City of Margate  
DEVELOPMENT REVIEW COMMITTEE  
Application for Site Plan

Project Name <b>LA PARRILLA RESTAURANT</b>		
Address <b>1875 N. STATE RD. 7.</b>		DRC # <b>03-15-01</b>
Acreage	Folio Number <b>484125-07-0662</b>	Paid: <b>\$250.00</b>
Existing Use <b>RESTAURANT</b>		
Legal Description <b>SEE SURVANT</b>

Describe proposal/request in detail, including non-residential square footage and/or number of dwelling units
<b>ADDING DUMPSTER ENCLOSURE &amp; DEBRIS STORAGE</b>
<b>CONTAINER W/ SIGN</b>

**SUBJECT: New Dumpster Enclosure –  
1875 N St Rd 7 Margate, FL 33067.**

SITE PLAN

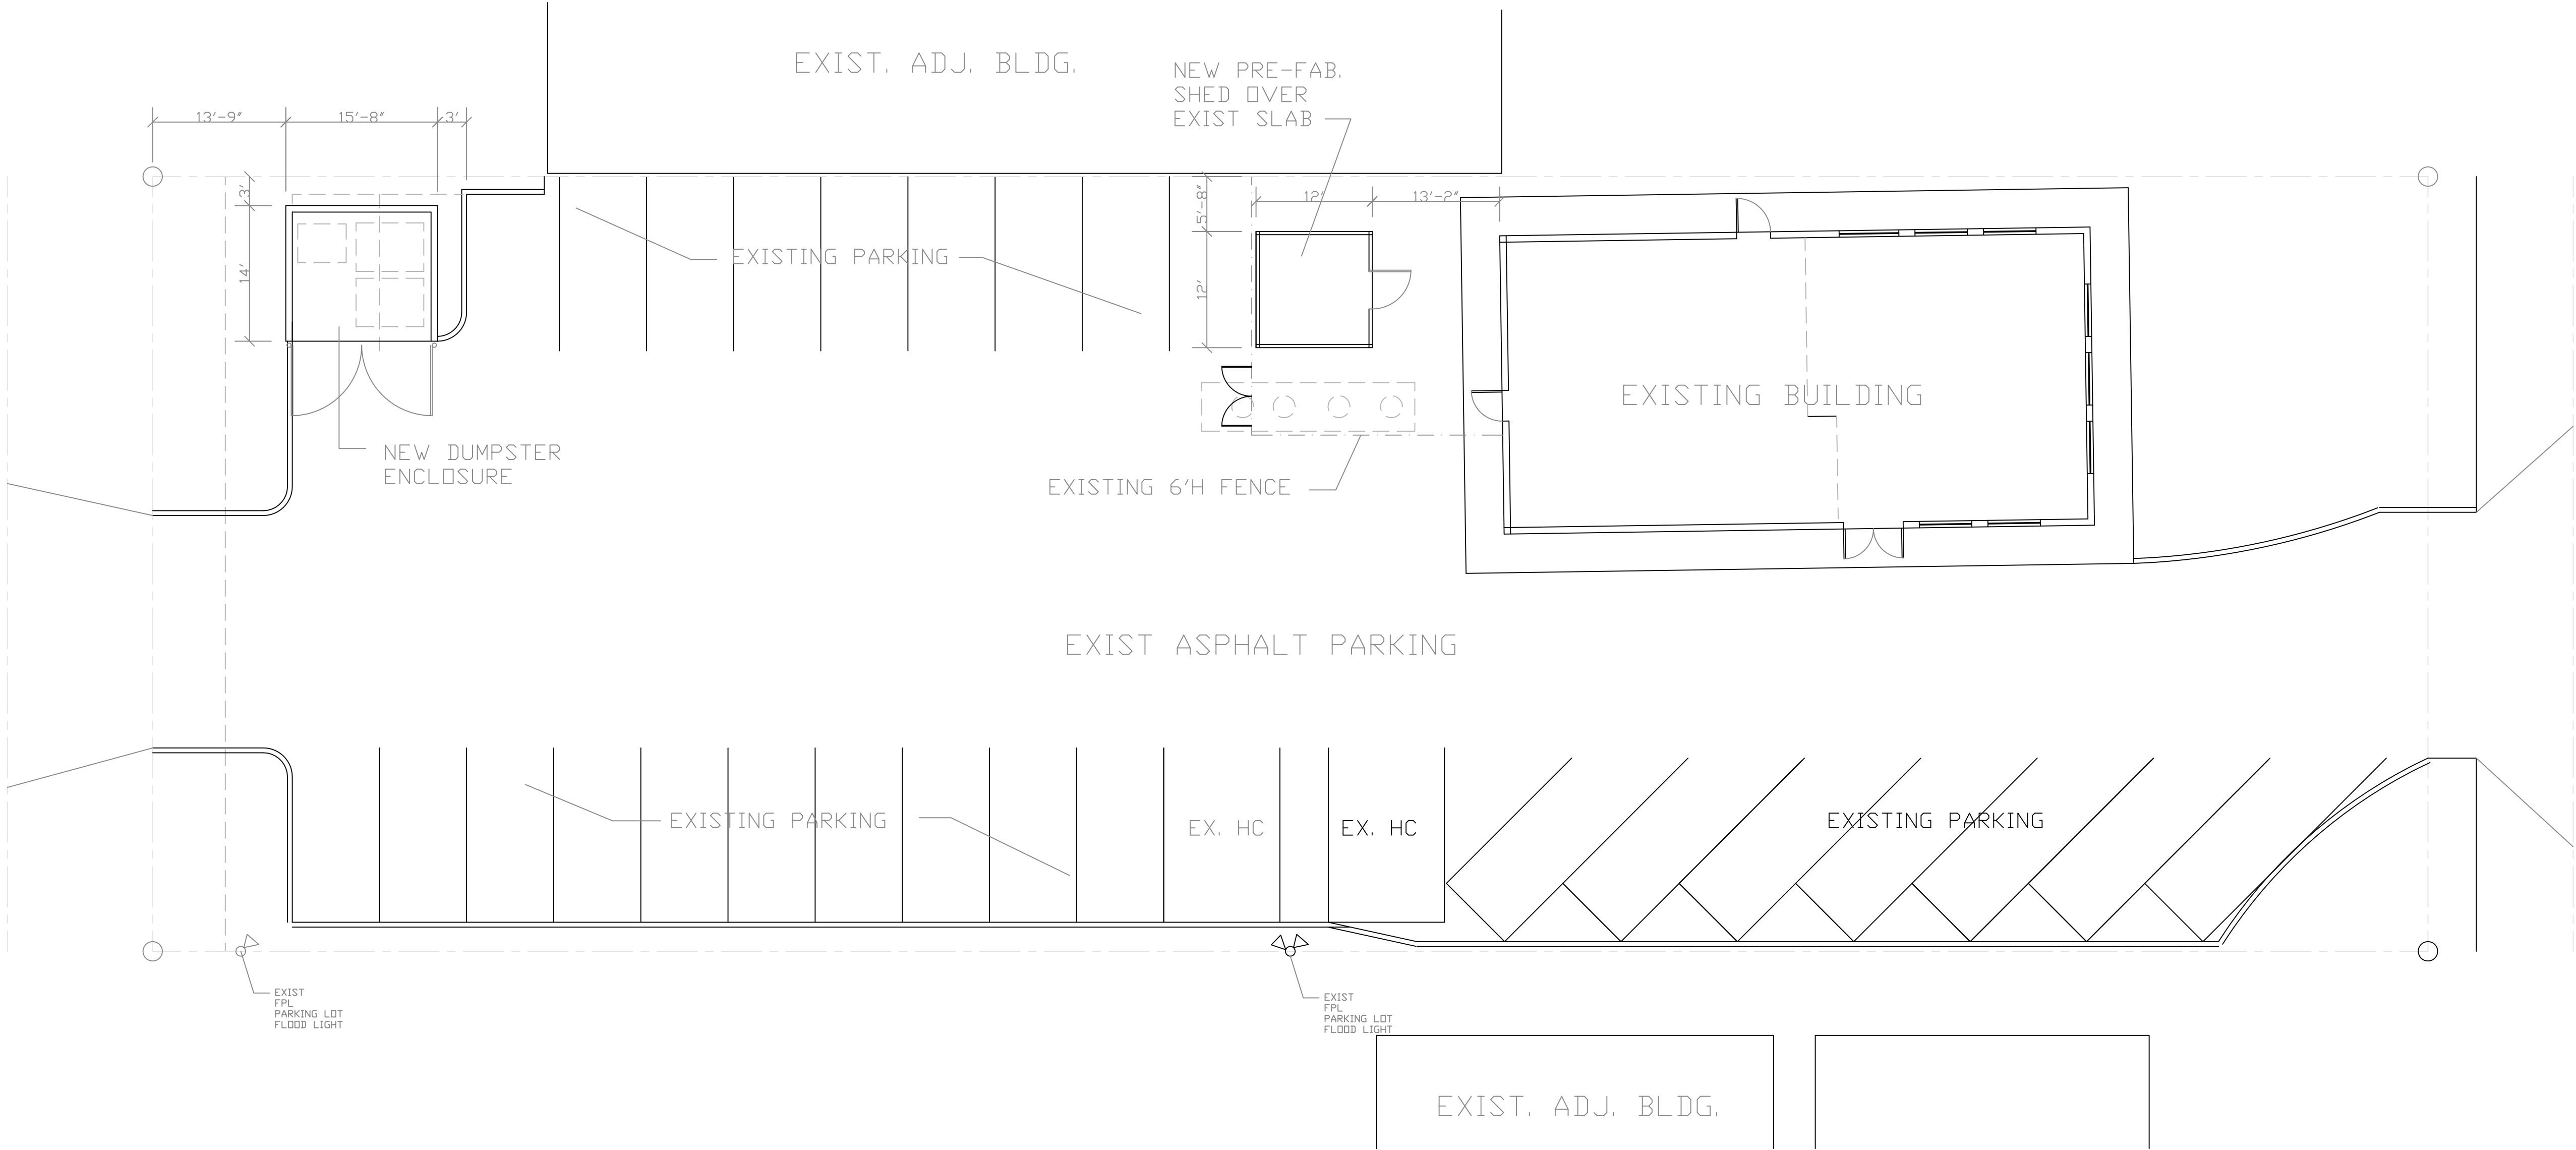
After viewing, the plans for the Dumpster enclosure for Parcel at the above address, the enclosure must be at least 12 by 12 with gates that open up 180 degrees. The Enclosure gates must have gate stoppers on them to keep the gates securely open while the driver services the property. I have attached our dumpster recommendations for reference in your building of the Enclosure.

Please note: any sharp turns or angles need to be approved by WM or it may impede the container from being serviced.

This letter serves as my approval for this site plan.
